VIRGINIA ELECTRIC AND POWER COMPANY  
RICHMOND, VIRGINIA 23261

**VIRGINIA ELECTRIC AND POWER COMPANY**  
**SURRY POWER STATION UNITS 1 AND 2**  
**PROPOSED TECHNICAL SPECIFICATION CHANGE AND**  
**SUPPORTING SAFETY ANALYSES REVISIONS TO ADDRESS**  
**GENERIC SAFETY ISSUE 191**

**PROPOSED TECHNICAL SPECIFICATION CHANGE AND  
SUPPORTING SAFETY ANALYSES REVISIONS TO ADDRESS  
GENERIC SAFETY ISSUE 191**

**DISCUSSION OF PROPOSED CHANGE**

Figure 2.1-1: Surry RWST Level Low ESF Initiation

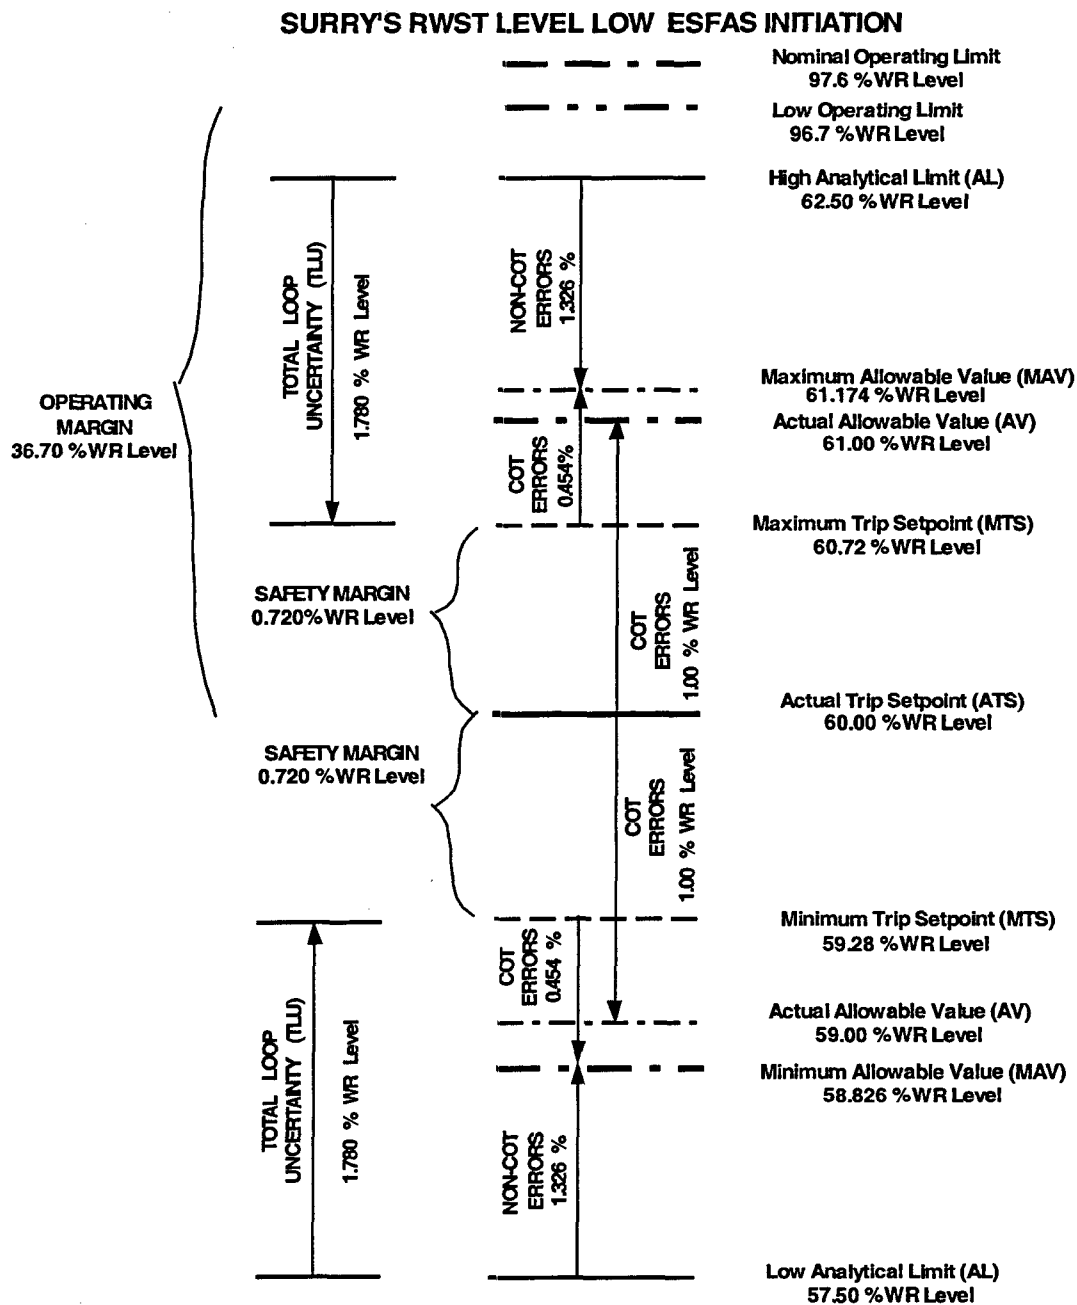
TS Setting Limit Values for the Surry RWST Level Low initiation can use the requirements of Methods 1 or 2 in ISA-RP67.04.02-2000 [20]. The determination of TS Setting Limit Values used Method 1. There are two Analytical Limits and thus two Setting Limits associated with this new function. The Analytical Limits are  $\geq 57.50$  % WR Level and  $\leq 62.50$  % WR Level. The corresponding TS Setting Limits are  $\geq 59.00$  % WR Level and  $\leq 61.00$  % WR Level from the following analysis. The reader is referred to Figure 2.1-1 for the relationship between the Analytical Limits and the TS Setting Limits.

The statistical combination of the COT and Non-COT error components is provided below and used in Figure 2.1-1 to determine the Minimum/Maximum Trip Setpoints and the Minimum/Maximum Allowable Values.

**Figure 3.10-1: Containment Air Partial Pressure versus Service Water Temperature  
(Proposed TS Figure 3.8-1)**

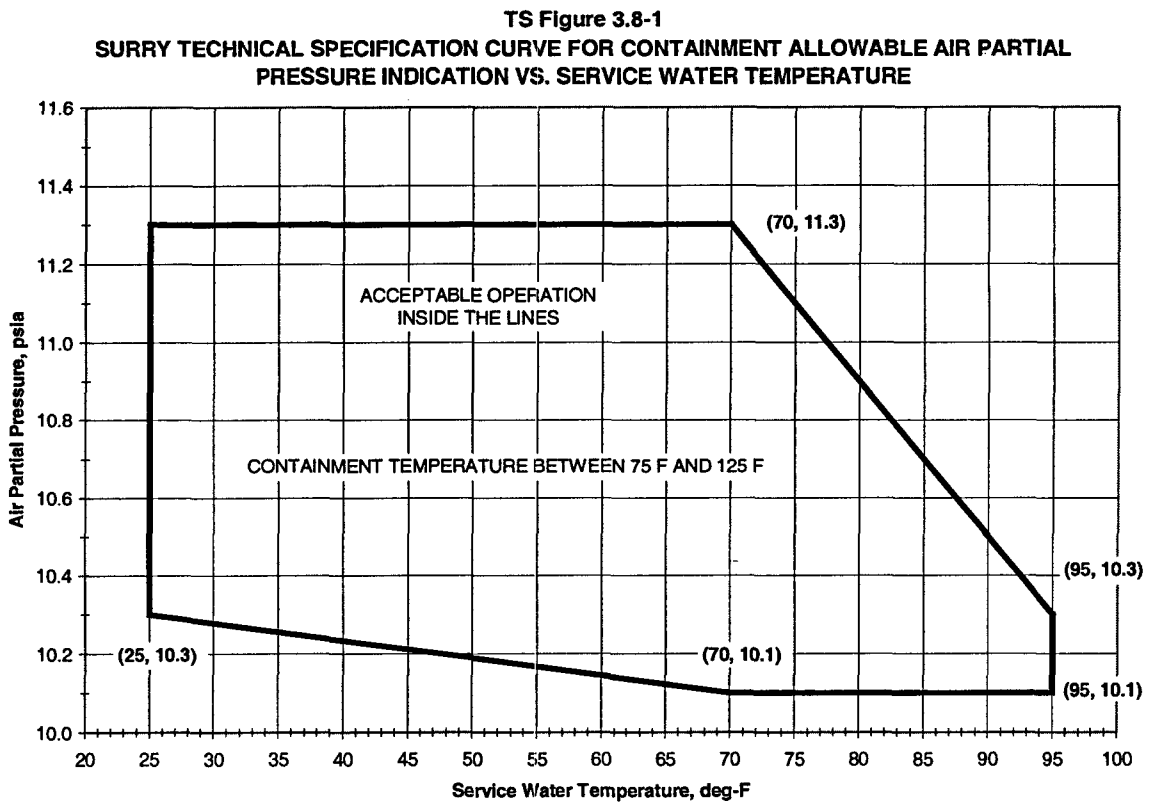
The GOTHIC containment analyses for LOCA containment peak pressure (Section 3.2), MSLB containment peak pressure (Section 3.7), and LOCA containment depressurization (Section 3.4) support an increase in the containment air partial pressure upper limit in TS Figure 3.8-1 from 10.3 psia to 11.3 psia. As a result, the TS lower limit will be increased above 9.0 psia to recover LHSI pump NPSH margin that has been reduced by the delayed RS pump start. The proposed TS lower limit linearly decreases from 10.3 psia at 25 F SW to 10.1 psia at 70 F SW then remains constant at 10.1 psia to 95 F SW. Operating margin has also been increased at high SW temperature (from 0.1 psi to 0.2 psi margin at 95 F). The proposed change to TS Figure 3.8-1 and the technical basis for the upper and lower limits are presented in Section 3.10 of this report.

Changes to the TS 3.8 Basis are required to reflect the technical basis for the revised TS Figure 3.8-1. The MSLB peak pressure analysis sets the horizontal upper limit line. The plant changes no longer support a “subatmospheric peak pressure” since some GOTHIC cases produce long-term pressures that exceed 0.0 psig. Therefore, it is proposed to change the description from “subatmospheric peak pressure” to “LOCA depressurization criteria” to reflect the positive pressure after one hour. Also, the minimum air partial pressure is being changed from a constant 9.0 psia to a variable line in order to recover NPSH margin at low SW temperatures. The TS Basis will be revised to reflect the variable lower limit in TS Figure 3.8-1.

TS FIGURE 3.8-1

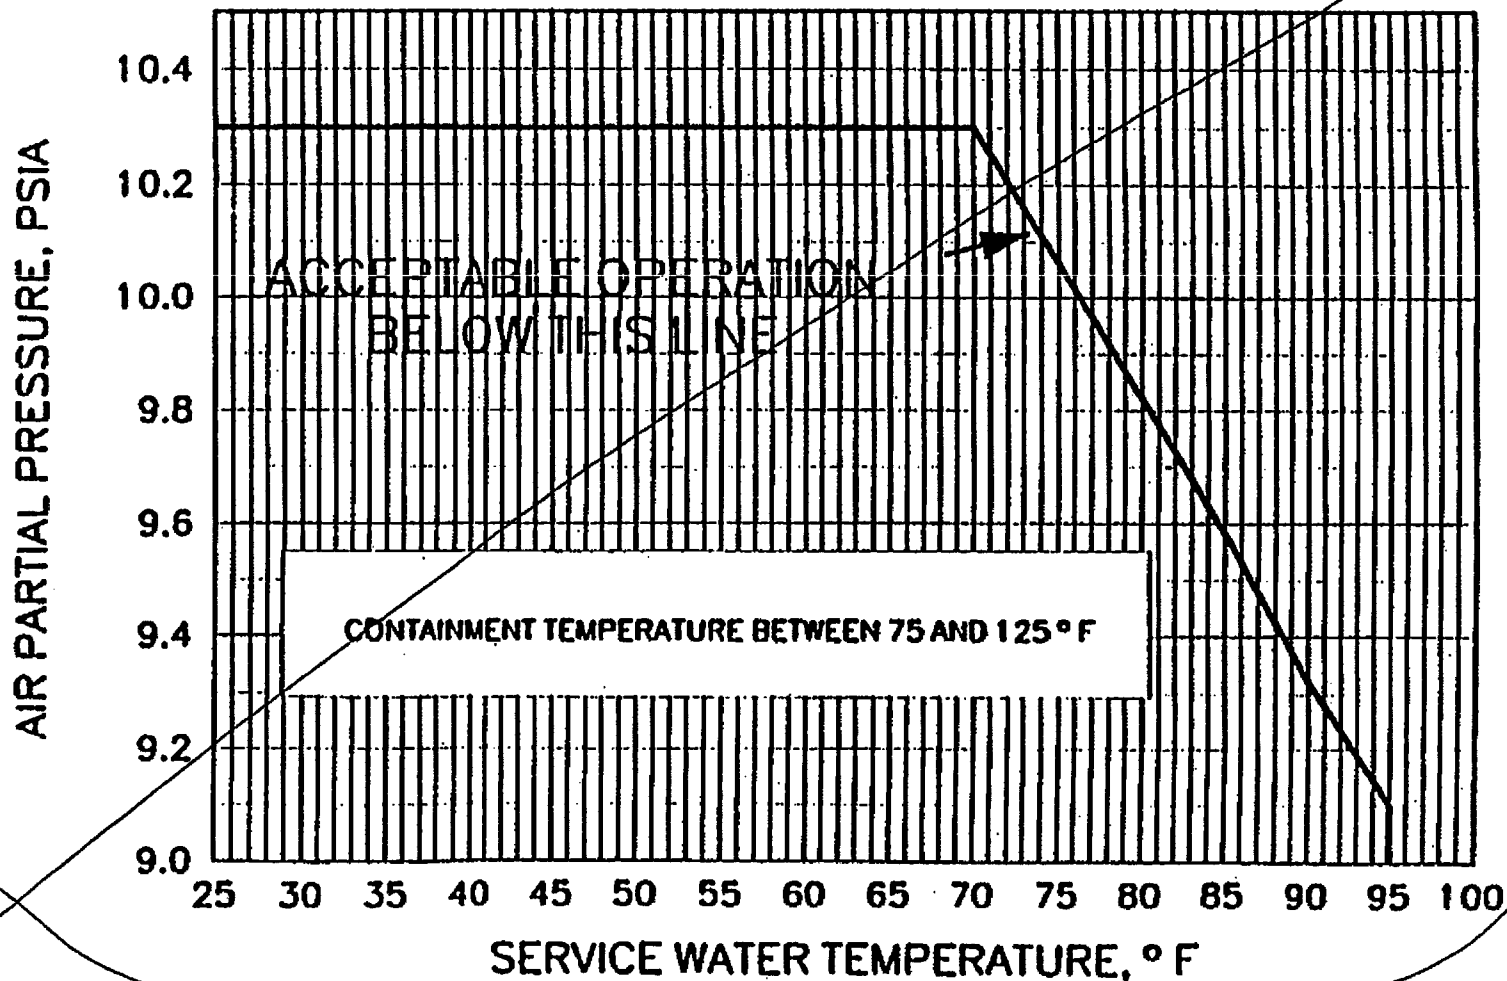
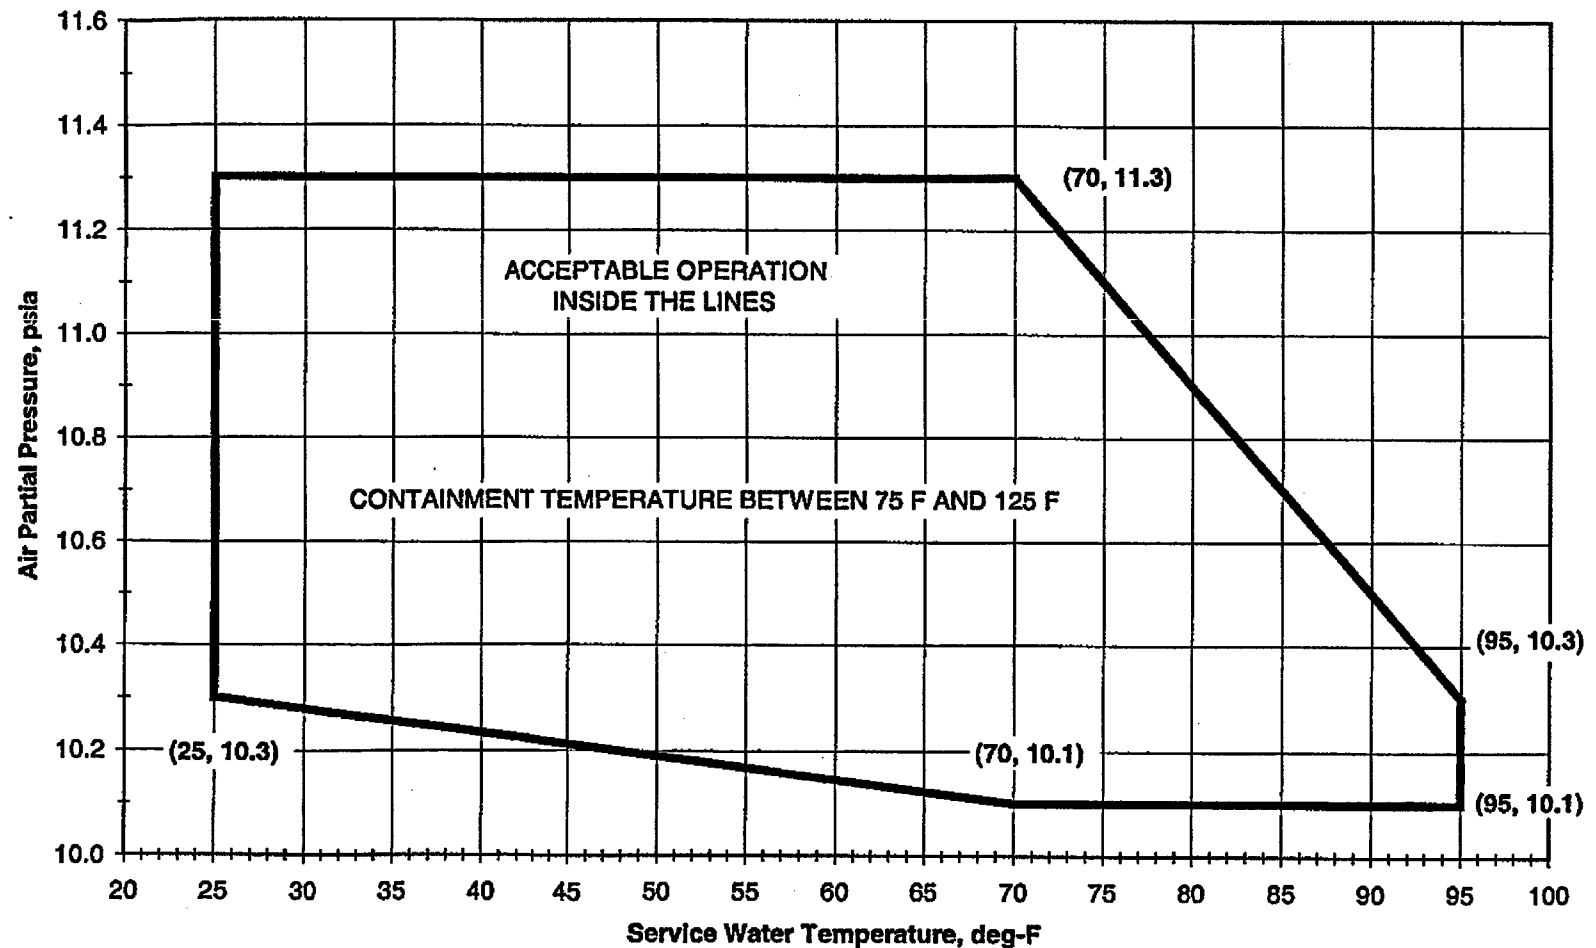
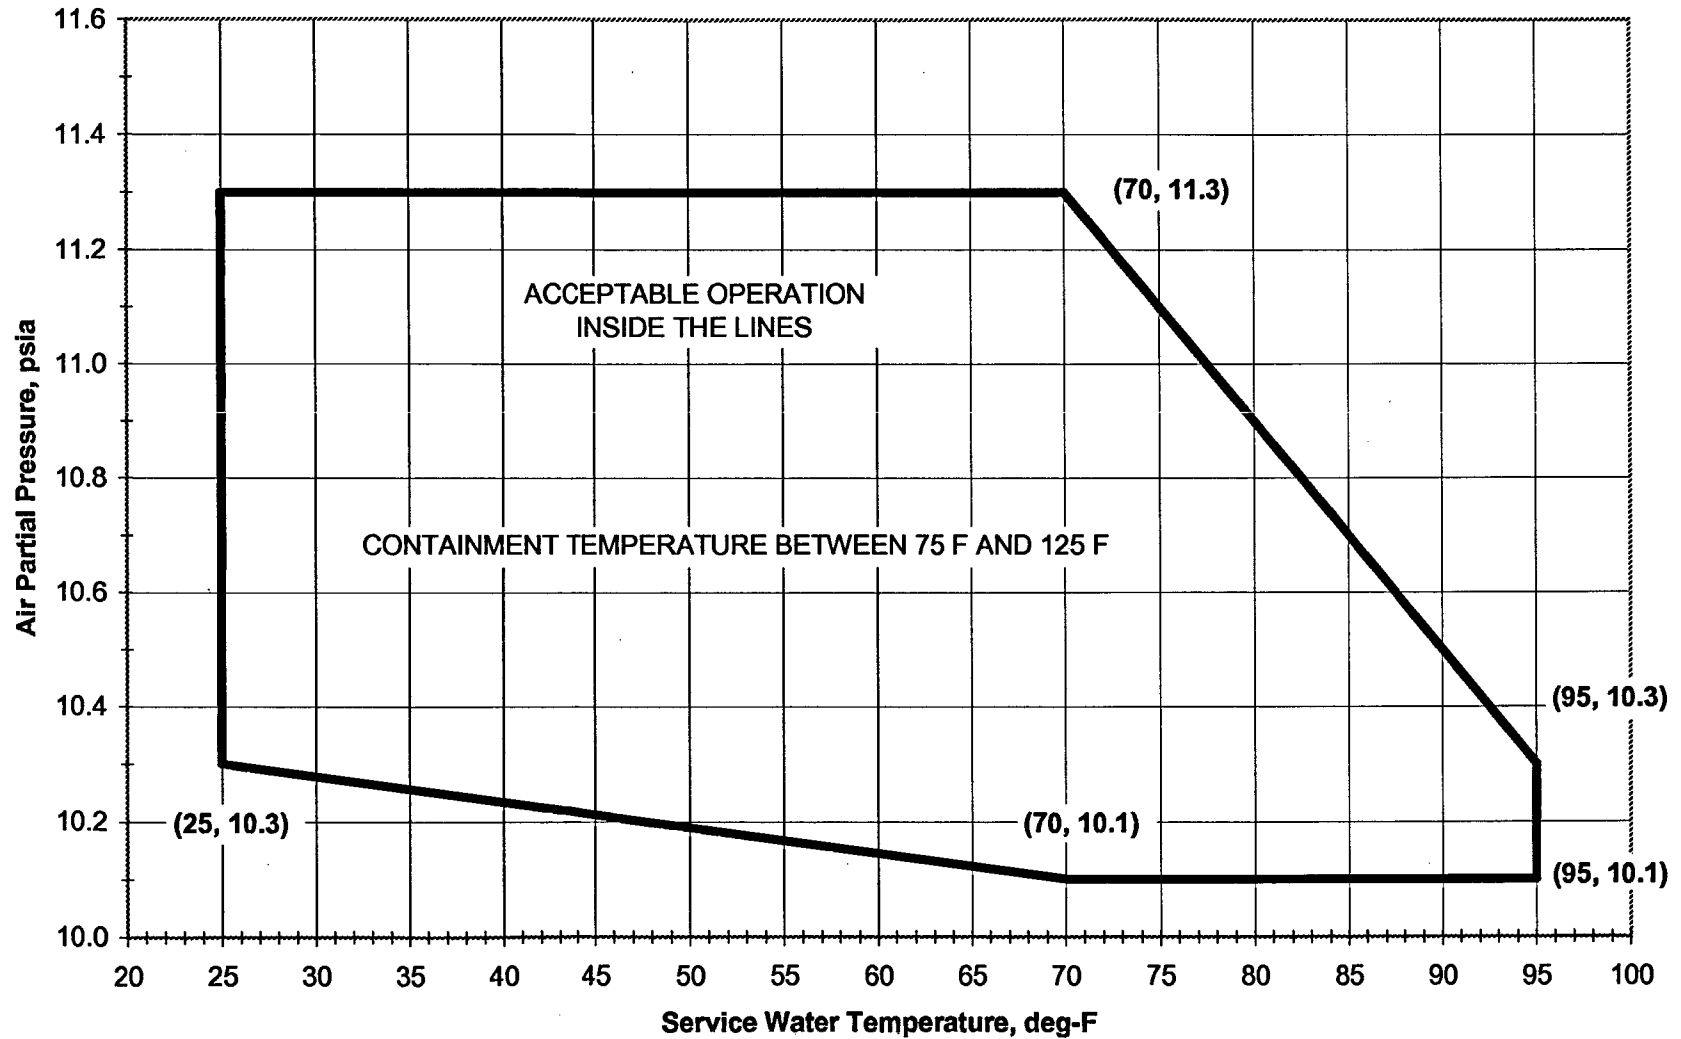
The horizontal <sup>UPPER</sup> limit line in TS Figure 3.8-1 is based on <sup>MSLB</sup> ~~LOCA~~ peak calculated <sup>DEPRESSURIZATION</sup> pressure criteria, and the sloped <sup>✓</sup> line is based on LOCA ~~subatmospheric peak~~ <sup>pressure</sup> criteria.  
FROM 70°F TO 95°F SERVICE WATER TEMPERATURES.

If the containment air partial pressure cannot be maintained greater than or equal to ~~9.0 psia~~ <sup>THE MINIMUM PRESSURE IN FIGURE 3.87</sup>, the reactor shall be brought to the HOT SHUTDOWN condition. The shell and dome plate liner of the containment are capable of withstanding an internal pressure as low as 3 psia, and the bottom mat liner is capable of withstanding an internal pressure as low as 8 psia.

INSERT #4 to TS 3.8: Replace Figure 3.8-1 with the below figure (Figure 3.10-1 in technical report NE- 1460

The horizontal upper limit line in TS Figure 3.8-1 is based on MSLB peak calculated pressure criteria, and the sloped line from 70°F to 95°F service water temperatures is based on LOCA depressurization criteria.

If the containment air partial pressure cannot be maintained greater than or equal to the minimum pressure in Figure 3.8-1, the reactor shall be brought to the HOT SHUTDOWN condition. The shell and dome plate liner of the containment are capable of withstanding an internal pressure as low as 3 psia, and the bottom mat liner is capable of withstanding an internal pressure as low as 8 psia.
